## Safety Bulletin

32131A01

### Euro couplings without non-return valve opener

STOCKHOLM April 10, 2012

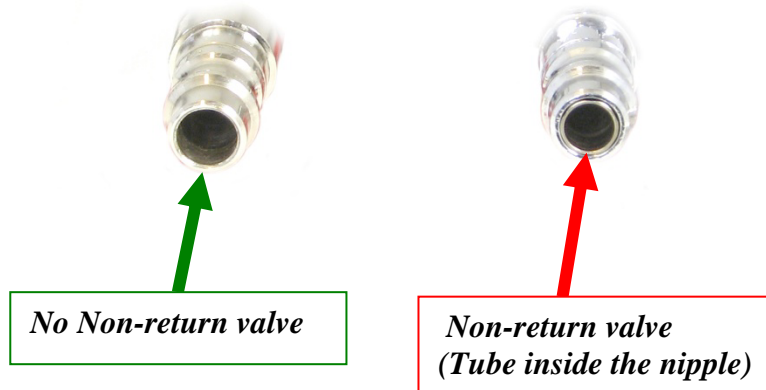
Interspiro has delivered the above configurations with female big Euro couplings without non return valve opener.

This female coupling does not open the non-return valve in the male connection nipple on some airline and rescue hoses. Normally, airline hoses do not have non-return valves in the male connection nipple, but some rescue/special hoses might have it.

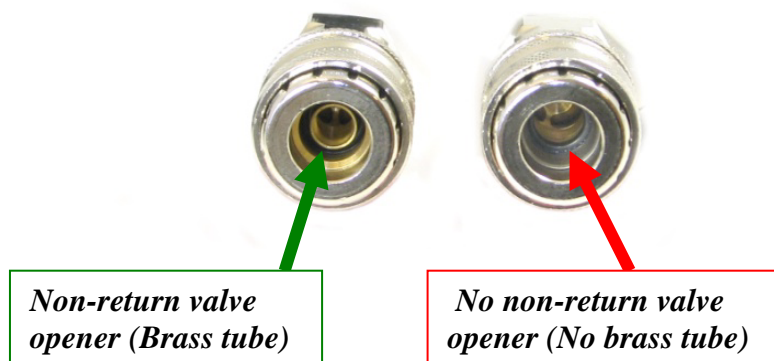
1. Check if there is a Non-return valve opener in the female connection. The non return valve opener is a brass tube located in the female coupling according to picture below. If the female coupling is equipped with the brass tube no further action is needed.

2. If the female coupling is without the brass tube it must be exchanged to the female extra air coupling with item number 95 244-01. Contact your local Interspiro representative for further information.
